HERITAGE PRESERVATION COMMISSION STAFF REPORT

ADDRESS: 777 6th Street E.

ZONING: RT1 **PROPOSAL:** Siding, window and rear porch work

New Egress plan submitted by applicant (structural plan required for building permit)

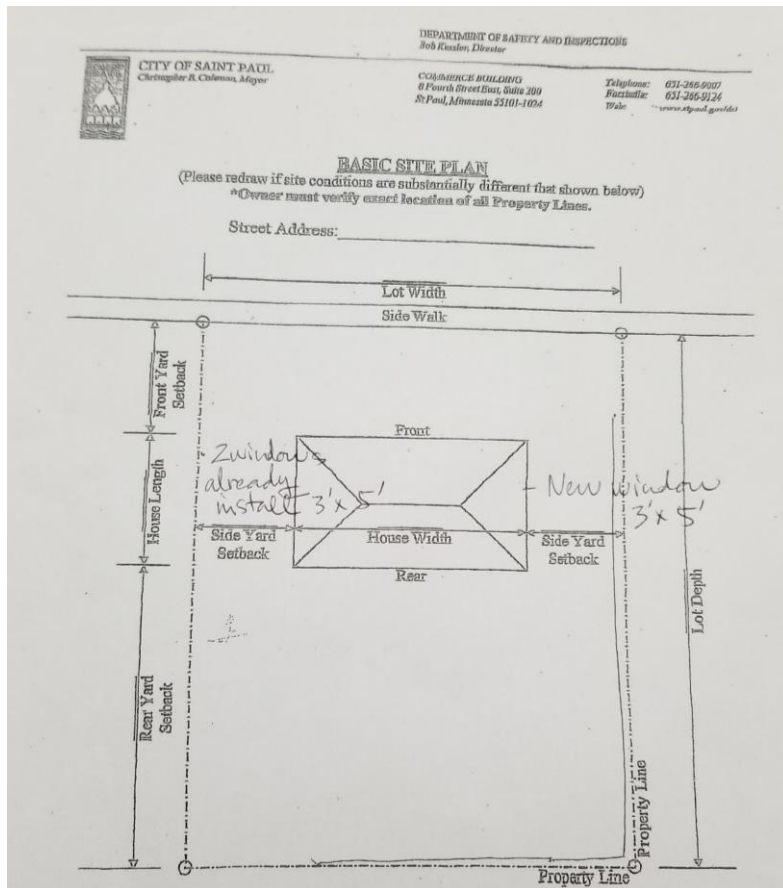
Egress: A new window is required by code for bedroom egress on the west façade of the house. The drawing submitted by the applicant shows a new window where one currently exists. After clarification from the applicant, the new window will be on the wall just forward of the existing window on the first floor.

12. The one new egress window shall match the size, style, profile, and configuration of the existing windows.
13. Authorization is written in conjunction with and referencing submitted application and plans. Conditions of this authorization MAY supersede any contradictory notes or schedules found on project description or drawings. This authorization is VOID if the approved description or plans are altered.

Location of replacement and new windows submitted by applicant.

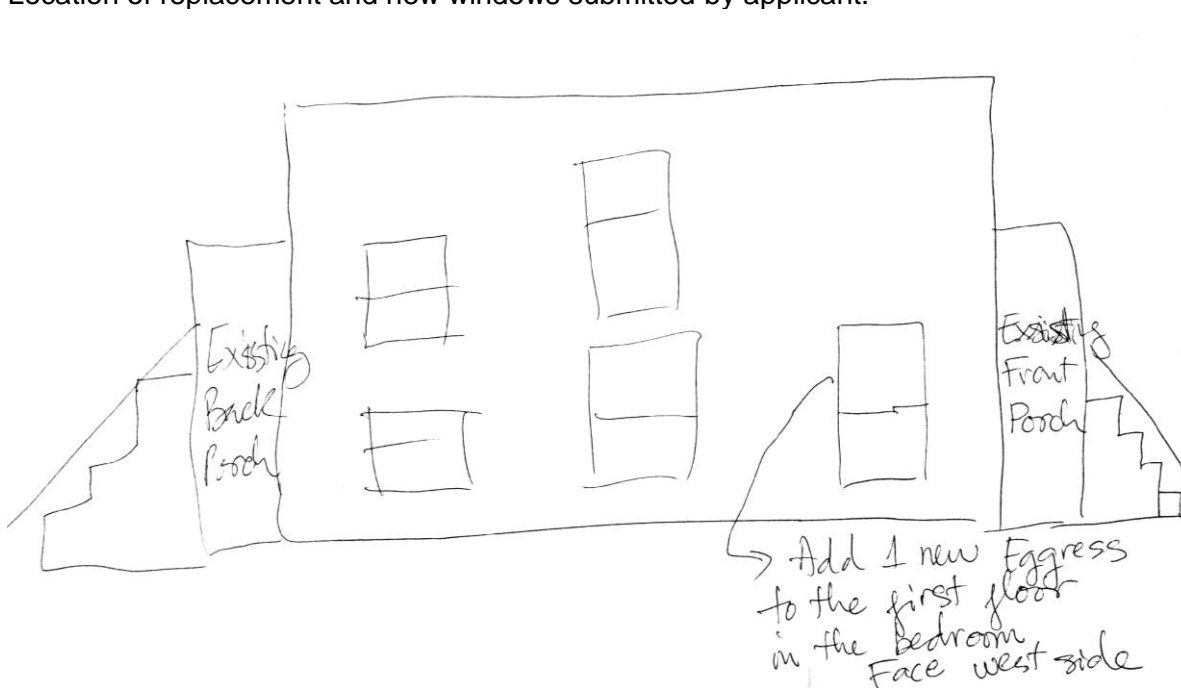
Windows: The round arch window and a multi-window on the east façade have both been altered and replaced. The applicant is proposing to reconstruct these windows back to the original configuration. Both window types exist on other Keller Row houses and are examples for reconstruction dimensions. Applicant proposes using a clad material for durability and maintenance.

The two windows that were altered, still exist on sister houses along the block. Those window configurations could be used for dimension and style standards in reconstructing the two window sets along the east façade.

7. There shall be no changes made to the existing window opening size.
8. Windows should not have brick mold casings.
9. Only factory installed exterior glass muntins shall be used. Interior muntins are not allowed.

10. Glass shall be clear, void of tint, color, or reflection.
11. The replacement windows shall match the size, style, profile, and configuration of the existing windows.
